Project	IEEE 802.16 Broadband Wireless Access Working Group < http://ieee802.org/16 >
Title	Proposed text to Subclause 1.3 Reference Models
Date Submitted	2007-05-02
Source(s)	Joey Chou Intel Corporation [mailto:joey.chou@intel.com]
Re:	
Abstract	This contribution proposes the text to subclause 1.3 Reference Models.
Purpose	Adoption
Notice	This document has been prepared to assist IEEE 802.16. It is offered as a basis for discussion and is not binding on the contributing individual(s) or organization(s). The material in this document is subject to change in form and content after further study. The contributor(s) reserve(s) the right to add, amend or withdraw material contained herein.
Release	The contributor grants a free, irrevocable license to the IEEE to incorporate material contained in this contribution, and any modifications thereof, in the creation of an IEEE Standards publication; to copyright in the IEEE's name any IEEE Standards publication even though it may include portions of this contribution; and at the IEEE's sole discretion to permit others to reproduce in whole or in part the resulting IEEE Standards publication. The contributor also acknowledges and accepts that

20 **Figure 1: BWA Network Reference Model**

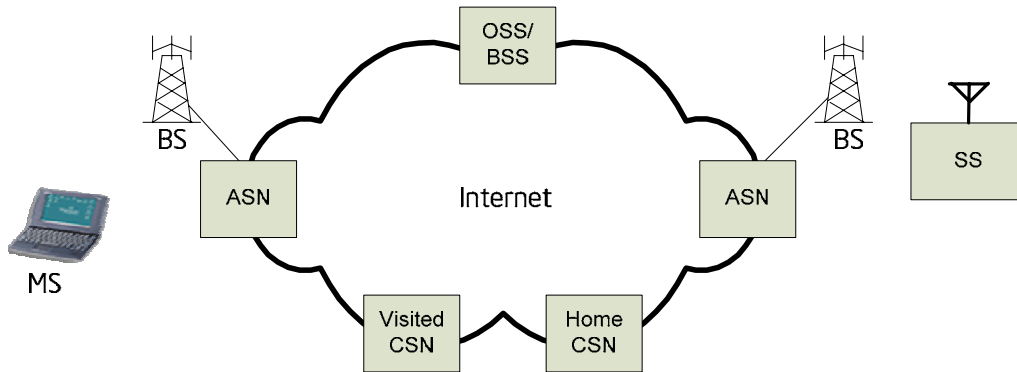
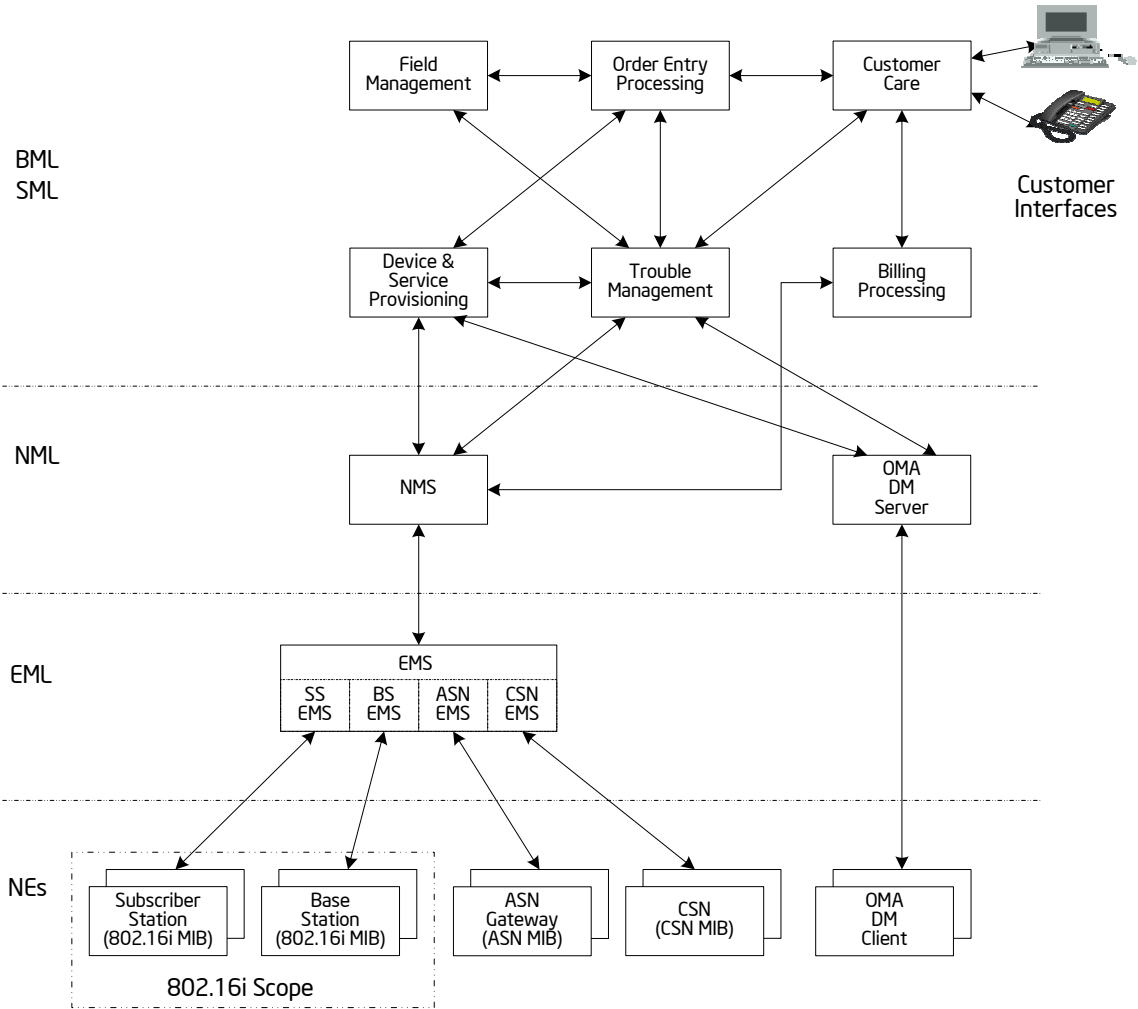
8 *[Replace Subclause 1.3 with the following:]*

10 Figure 1 shows the network reference model for both fixed and mobile Broadband Wireless Access
11 (BWA) networks that consists of OSS/BSS (Operation Support System / Business Support System) and
12 the following network elements:

- 13 • MS (Mobile Station)
- 14 • SS (Subscriber Station)
- 15 • BS (Base Station)
- 16 • ASN (Access Service Network)
- 17 • CSN (Connectivity Service Network)

22 OSS/BSS manages BS, ASN, CSN via the standard IP networks. Internet. For managed SS, OSS/BSS can
23 send the management information over the secondary management connection between BS and SS.
